GREAT WOLF LODGE, CHESTERTON, BICESTER

Proposed Non-Material Amendment (S.96a) Application Design Changes

November 2023

This document has been prepared by EPR Architects in support of a Non-Material Amendment (NMA) application associated with proposed changes to application ref 21/04158/F.

Proposed Amended Scheme - South-West Elevation

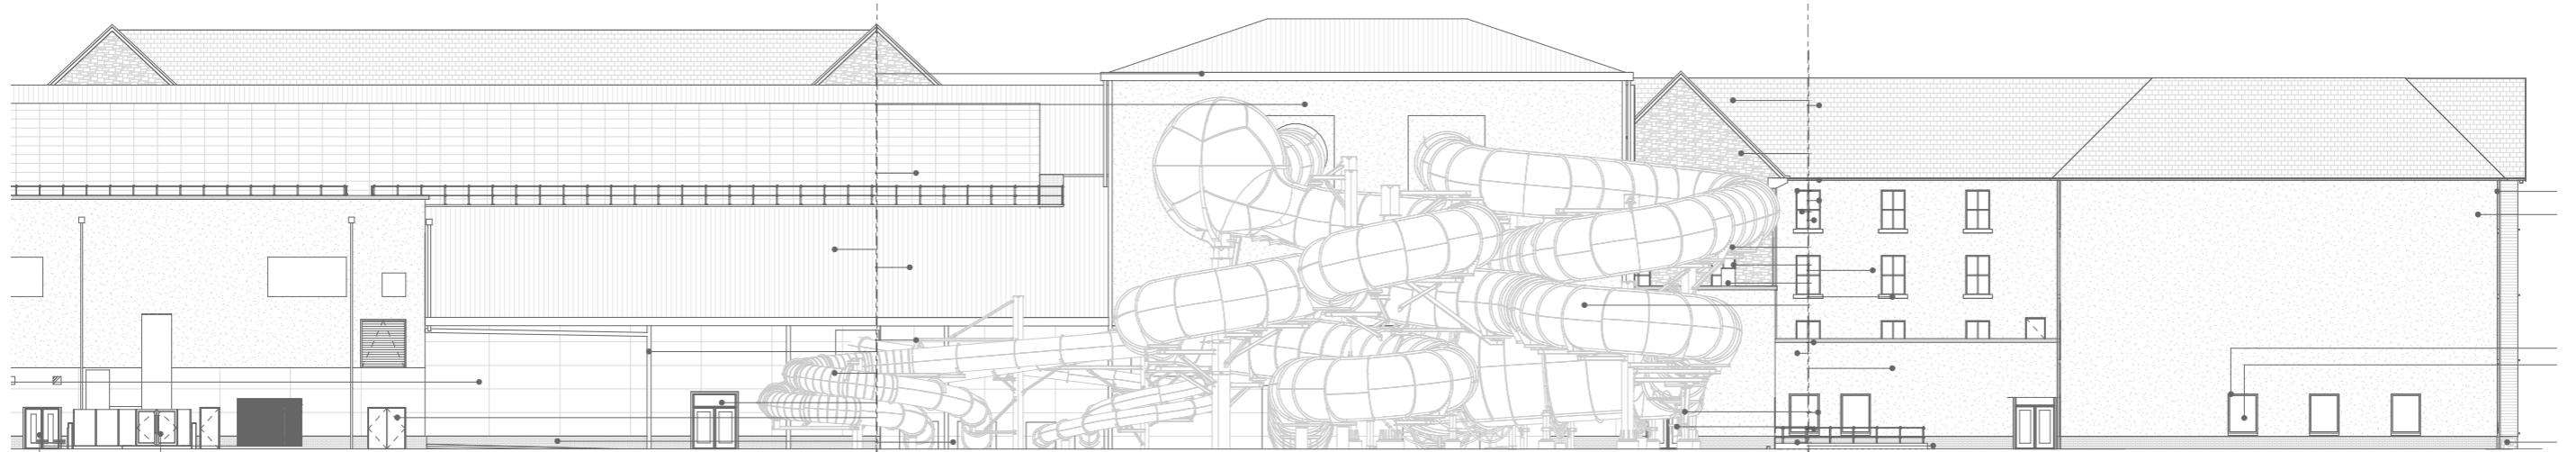
- ① Change of rear of hotel from stone to render retaining stone surrounds and sills
- ② Reduction of brick plinth to back of house areas of waterpark building / change to buff brick from blue brick material
- ③ Change of rear of hotel from stone to timber with timber surrounds and metal sills
- ④ Introduction of Ventilation grilles above all guestroom windows
